REQUEST FOR INFORMATION DATE: May 27, 2016 NO.: RFI-114

Project Name: 15051-Webster University Interdisciplinary Science Building Project No.: 15051

Subject: Condensate Trap Detail

A/C DRAIN TRAP PIPING DETAIL

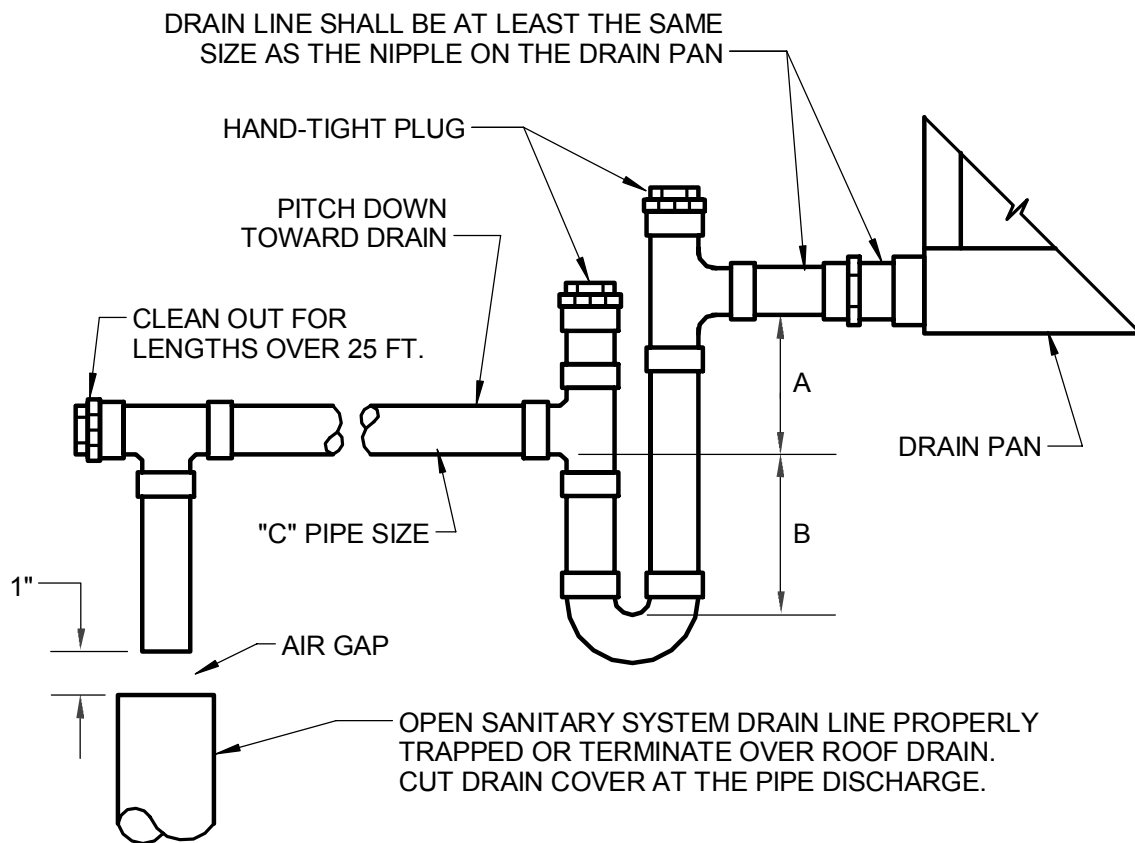
The details in the mechanical drawings do not show a typical detail for condensate traps.

Is there a typical condensate trap detail that needs to be followed or will manufacturer's recommendations suffice?

Manufacturer's recommendations are sufficient with plugs for cleaning, see attached detail.

UNIT TYPE	A	B	
DRAW THRU	2" PLUS X	X	
BLOW THRU	1" MIN	2X

Where x = static pressure in pan
